BOWMANS CREEK WIND FARM (SSD-10315)

This letter has been prepared to provide further information and respond to recommendations, as requested by DPE, Heritage NSW and BCD.

The Obstacle Lighting Plan reflecting DoD and CASA requirements is provided in **Figure 1** below.

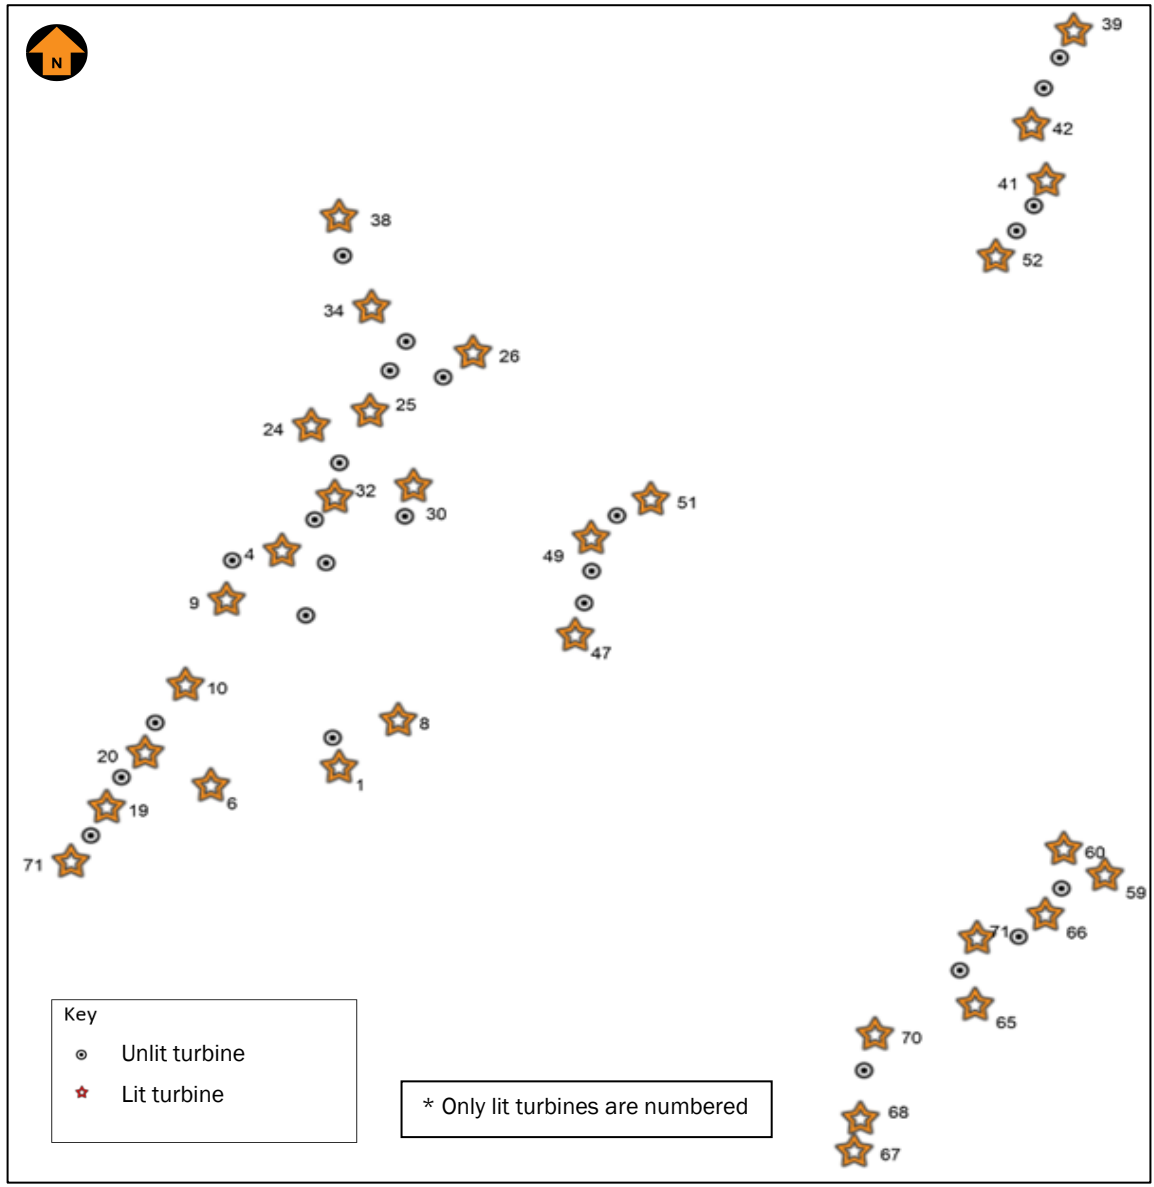
- Assess the impacts of the proposed night-lighting on all potentially impacted receivers.

Further to the above, extensive consultation has been undertaken with the Department of Defence (DoD) and Civil Aviation Safety Authority (CASA) over the requirement for aviation hazard lighting of the WTGs. The Proponent wishes to establish protocols to limit the amount of time the lights are energised, as well as minimise the lighting intensity to 200 candela.

CASA considered it would be acceptable to reduce the obstacle lighting intensity from medium 2000 candela intensity to minimum 200 candela intensity on the basis that there is limited background illumination. Furthermore, CASA recommended that the obstacle lights are energised during the hours of darkness and periods of low visibility as there could be civil aircraft in the area at night when the DoD Restricted Area is not active.

The DoD has confirmed that the night time lighting is not required for DoD operations as low level flying is not undertaken in the area during the night. Obstacle lighting requirements for DoD operations would only be implemented for low light daytime conditions of less than 5,000 lux. A lighting intensity of 2000 candelas would therefore be more appropriate. DoD have also agreed that daytime lighting could operate on a photoelectric switch, coupled with a time of day switch, which would automatically enable the lighting under poor visibility conditions.

1. Light and Shielding Specification:
 - Lights:*
 1. **Medium intensity** steady red obstacle lights - must be visible in all directions in azimuth;
 2. The peak effective intensity of medium-intensity obstacle lights must be 2 000 +/- 25% cd with a vertical distribution as follows:
 - a. for **vertical beam spread** – a minimum of 3 degrees;
 - b. at -1 degree elevation – a minimum of 50% of the lower tolerance value of the peak intensity;
 - c. at 0 degrees elevation – a minimum of 100% of the lower tolerance value of the peak intensity.
 3. For subsection (2), **vertical beam spread** means the angle between 2 directions in a plane for which the intensity is equal to 50% of the lower tolerance value of the peak intensity.

- Shielding:*
1. Shielding of the downward component of obstacle lighting is permitted, and if used must be such that:
 - a. no more than 5% of the nominal light intensity is emitted at or below 5° below horizontal
 - b. no light is emitted at or below 10° below horizontal
 2. Obstacle lights must be provided on top of the generator housing in a way that allows lights to be seen from every angle in azimuth (may require 2 lights to fulfil this requirement).

Department of Defence obstacle lighting requirement:

1. Operation of lights is for low light **daytime operations only (<5000 lux)**
2. **Not required to be lit at night (all lights OFF at night as no low-level flying operations taking place)**
3. the frequency range of the LED light emitted must fall within the range of wavelengths 655 to 930 nanometers.
